Contract No. T201112201.01
Federal Aid Project No. NHS-K008(13)
SR 1, NE Front Street Grade Separated Intersection
Kent County

Enclosed is Addendum No. 4 for the referenced contract consisting of the following:

TYPICAL SECTIONS	SHEET NO. 9
	TOTAL SHTS. 236

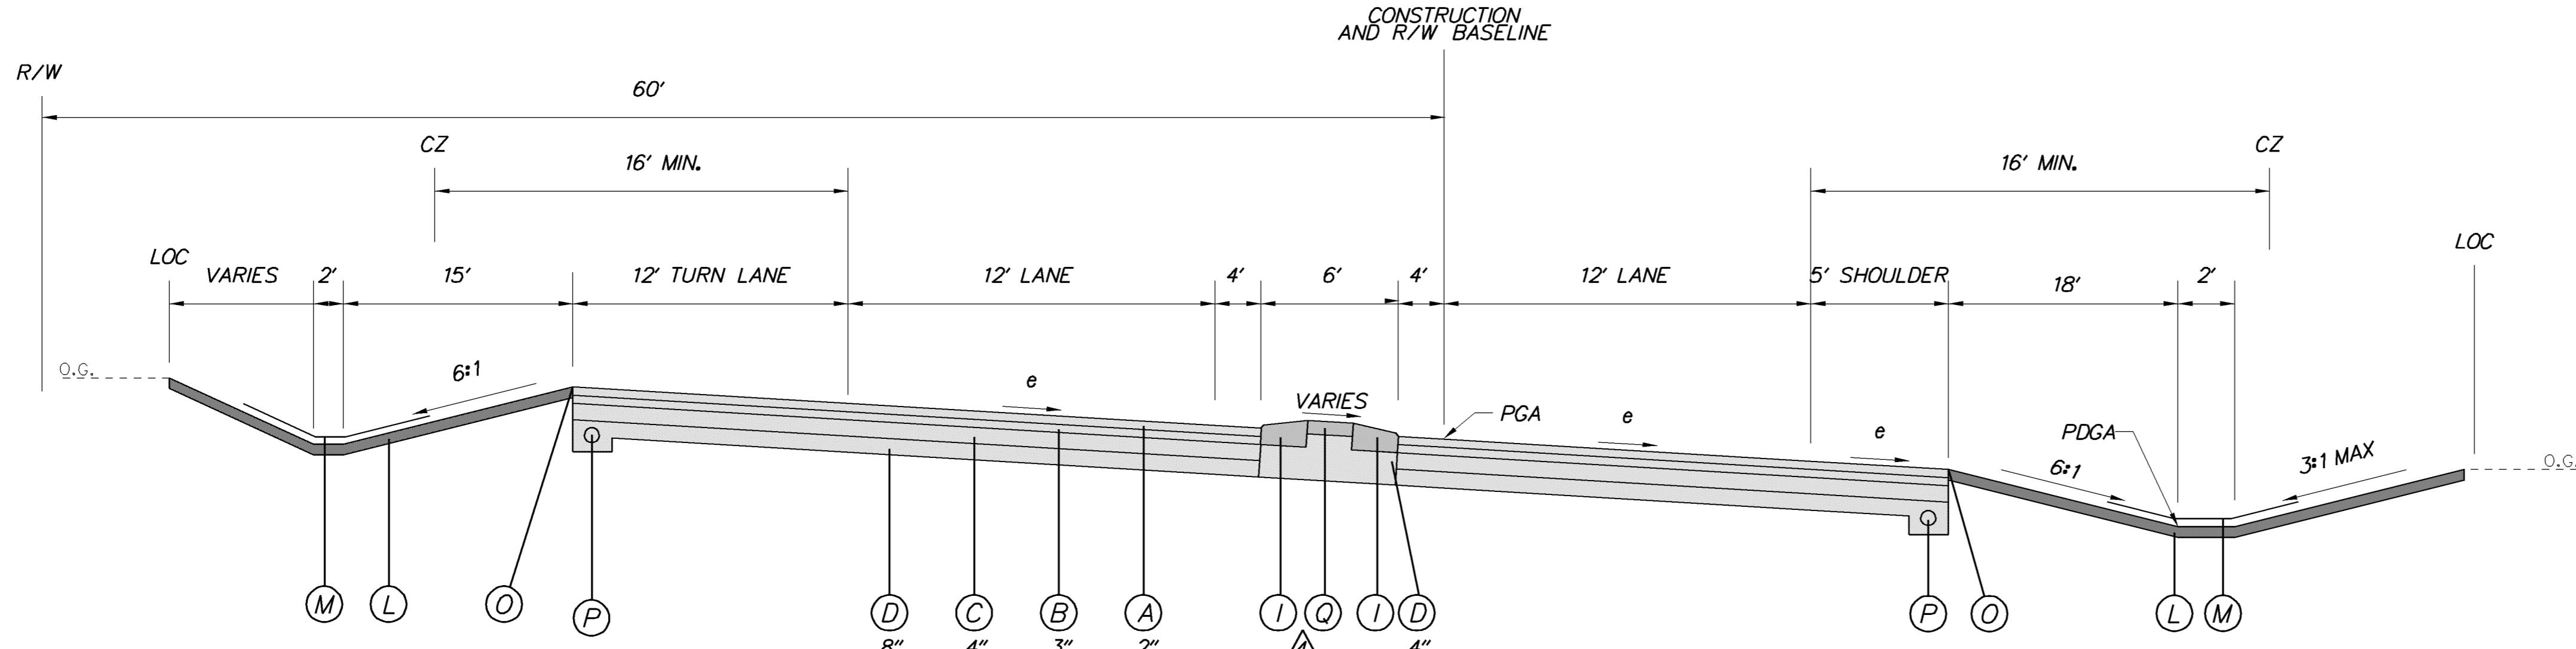
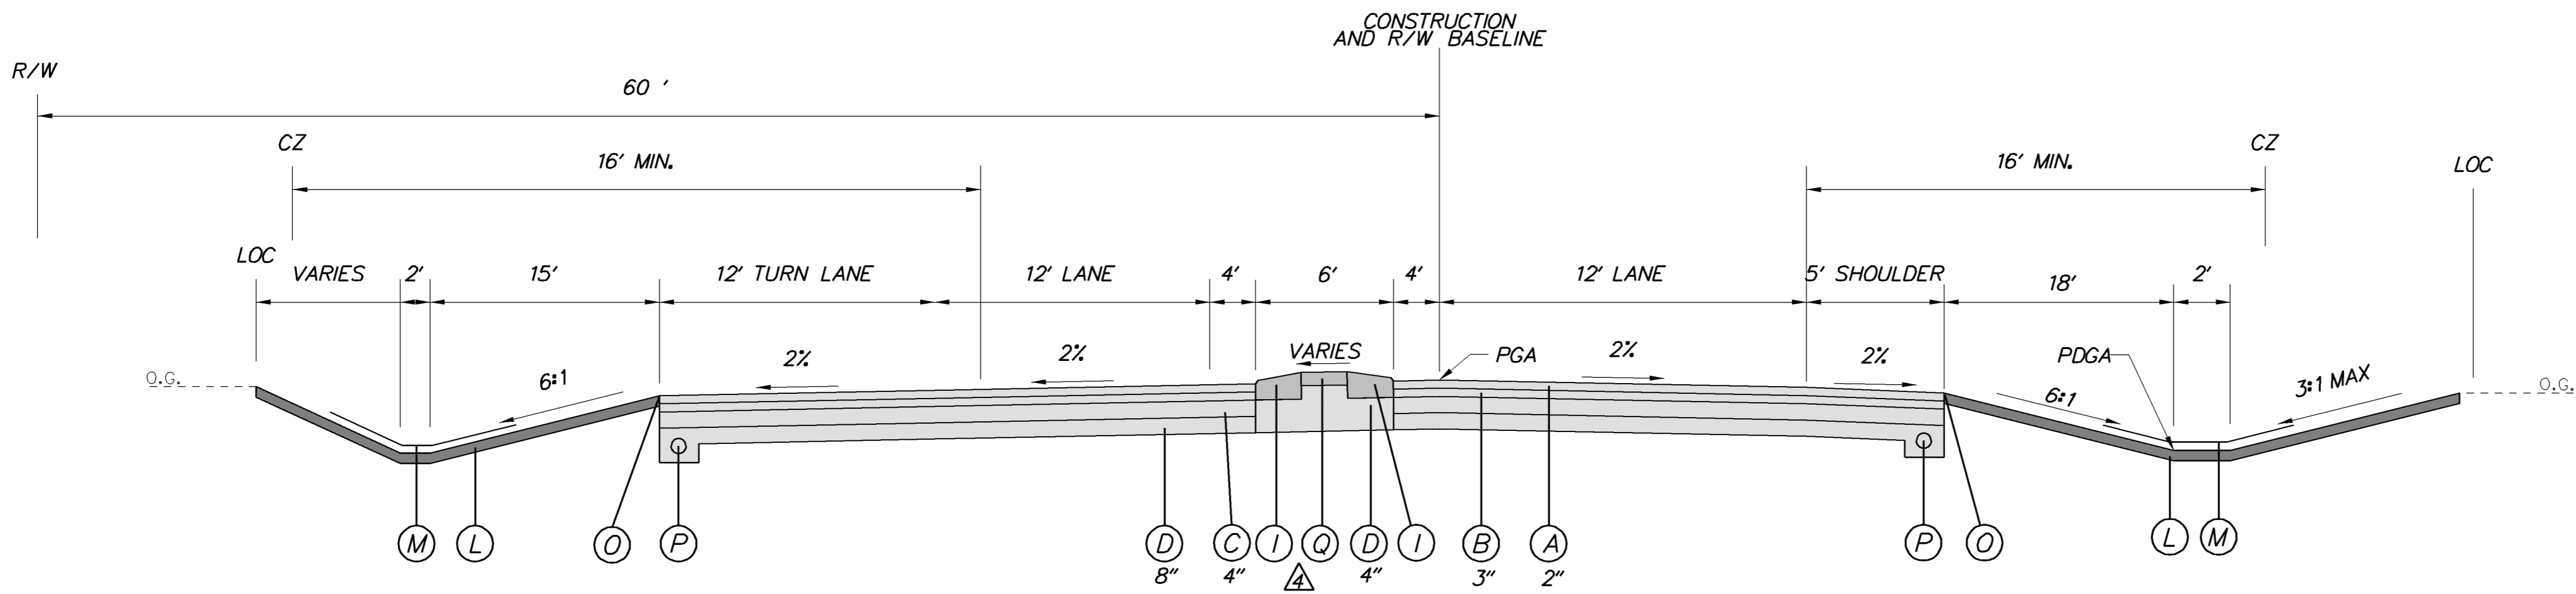
ADDENDUMS / REVISIONS	
(R) ADDED 8" SIDEWALK ITEM (Q)

- (Q) ITEM 715001 - PERFORATED PIPE UNDERDRAINS, 6"
- (R) ITEM 705005 - P.C.C. SIDEWALK, 8"

SHEET NO. 11
TOTAL SHTS. 236

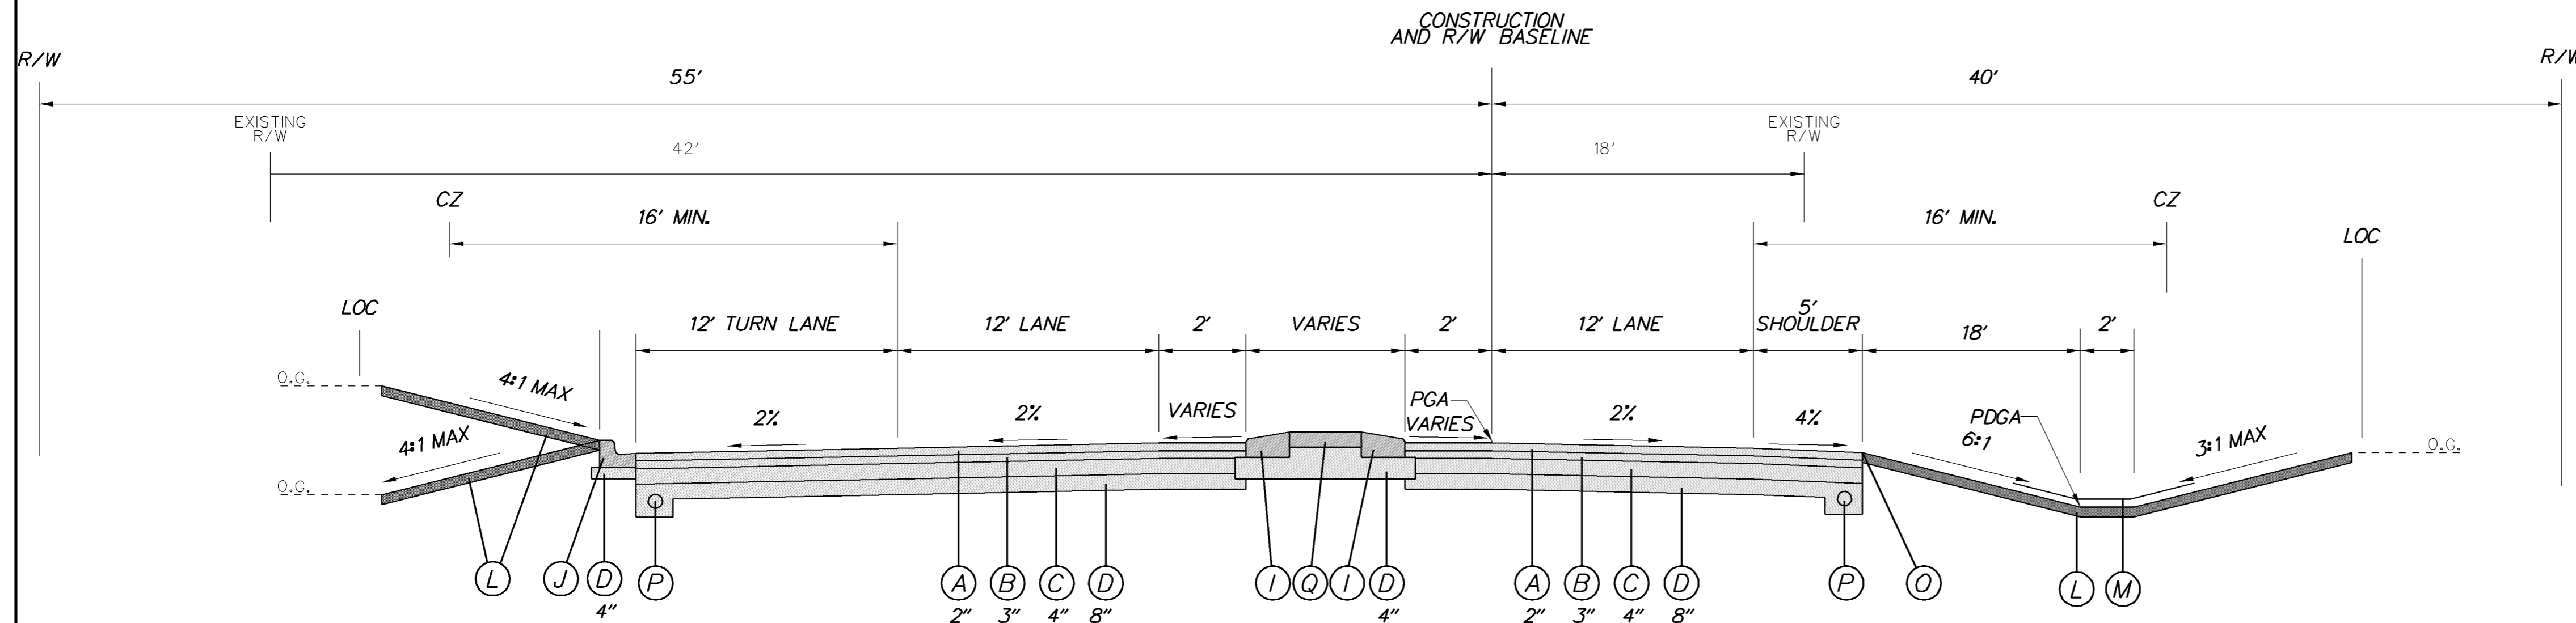
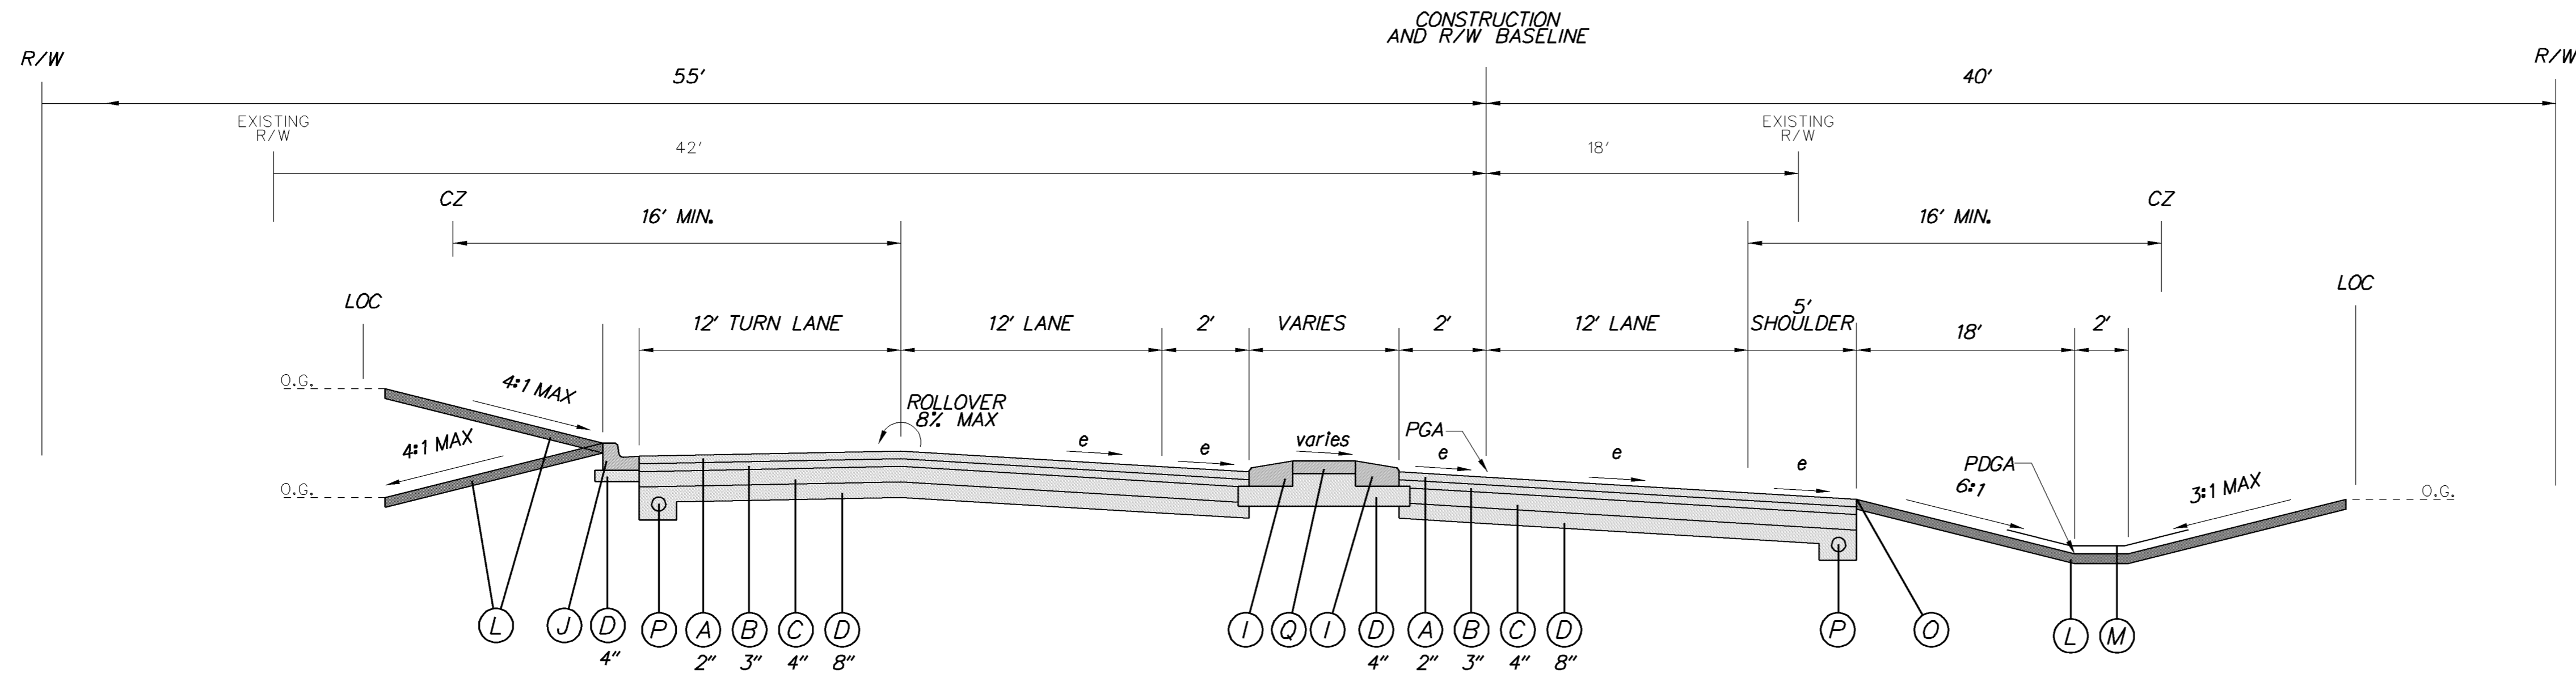
ADDENDUMS / REVISIONS	
(R) ADDED 8" SIDEWALK ITEM (Q)

PN-02
SHEET NO.
60
TOTAL SHTS.
236

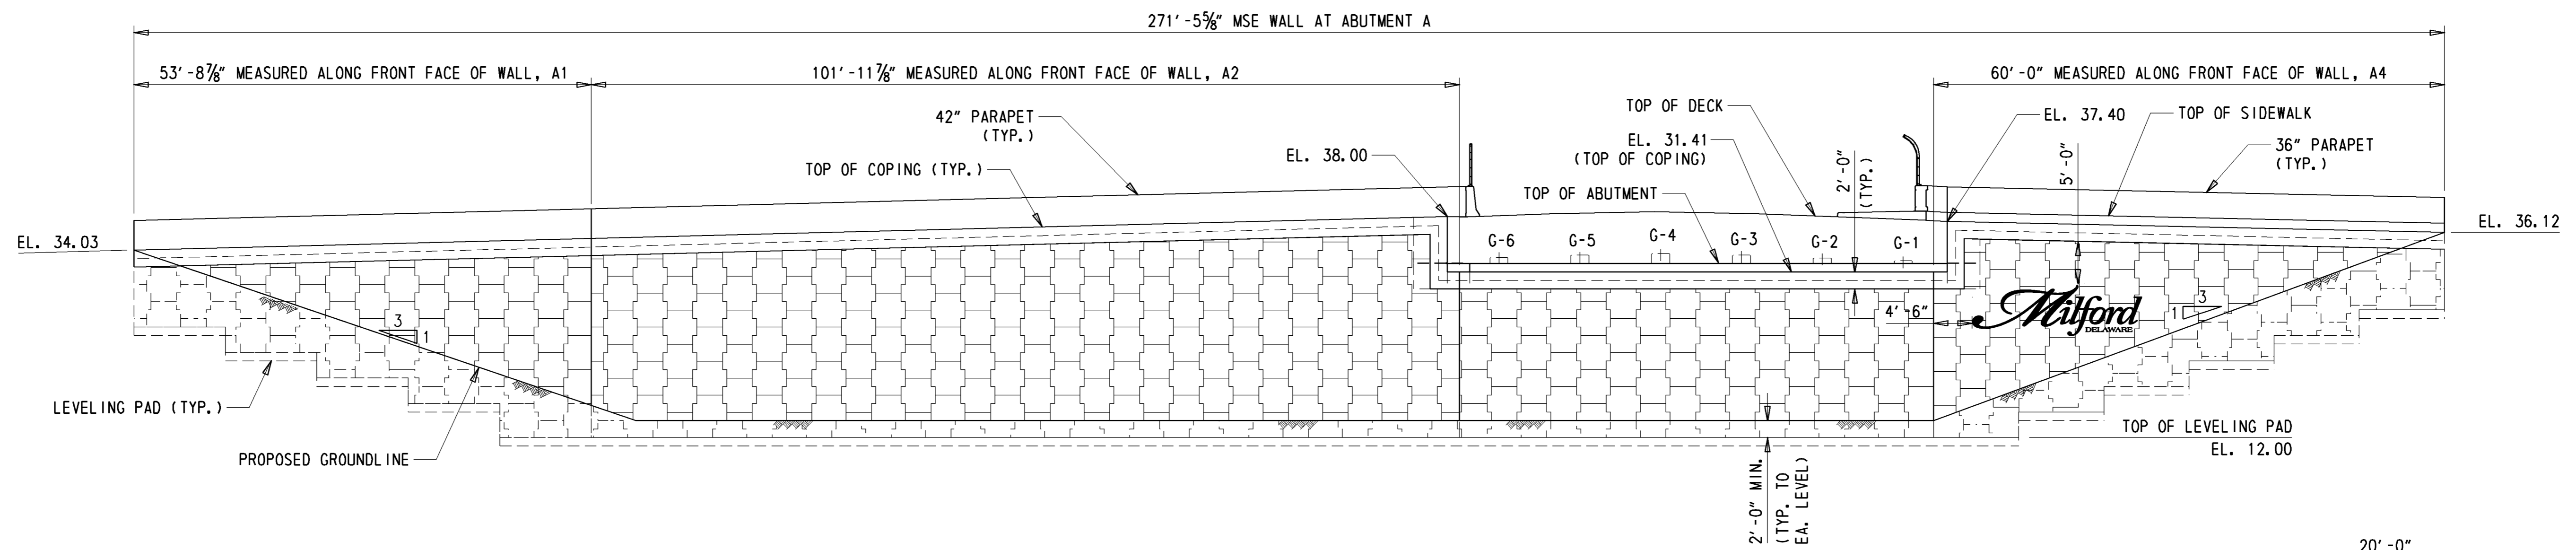
9. The following Plan Sheets have been revised and replaced: 4, 9, 11, 59, 60, 67 and 236a.
10. Expedite File Disc, Amendments No. 2
